Addendum 112 – Regulation No. 113

Revision 3 - Amendment 2

Supplement 2 to the 01 series of amendments – Date of entry into force: 15 July 2013

Uniform provisions concerning the approval of motor vehicle headlamps emitting a symmetrical passing-beam or a driving-beam or both and equipped with filament, gas-discharge light sources or LED modules

Figure 1

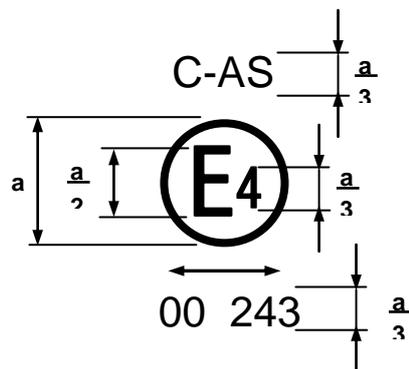
Annex 2, amend to read:

Examples of arrangement of approval marks

$a \geq 5$ mm for Class A headlamp

..."

"Annex 8

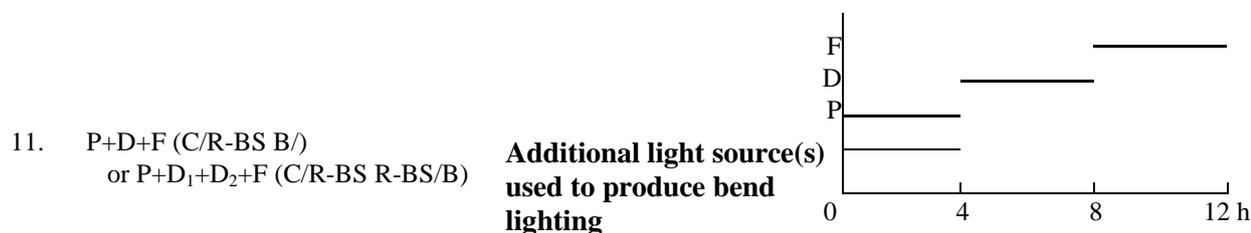
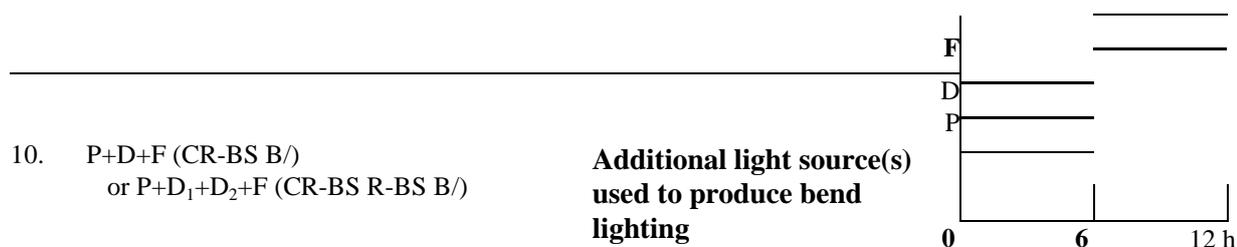
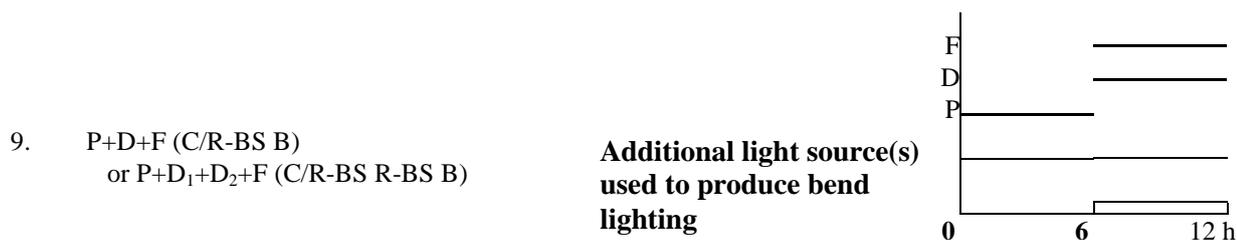
Annex 8, amend to read:

1.	P or D or F (C-BS or R-BS or B)	Additional light source(s) used to produce bend lighting	P, D or F
----	---------------------------------	---	-----------

2.	P+D (CR-BS) or P+D ₁ +D ₂ (CR-BS R-BS)	Additional light source(s) used to produce bend lighting	
3.	P+D (C/R-BS) or P+D ₁ +D ₂ (C/R-BS R-BS)	Additional light source(s) used to produce bend lighting	
4.	P+F (C-BS B)	Additional light source(s) used to produce bend lighting	
5.	P+F (C-BS B/) or C-BS/B	Additional light source(s) used to produce bend lighting	
6.	D+F (R-BS B) or D ₁ +D ₂ +F (R-BS R-BS B)	Additional light source(s) used to produce bend lighting	
7.	D+F (R-BS B/) or D ₁ +D ₂ +F (R-BS R-BS B/)	Additional light source(s) used to produce bend lighting	
8.	P+D+F (CR-BS B) or P+D ₁ +D ₂ +F (CR-BS R-BS B)	Additional light source(s) used to produce bend lighting
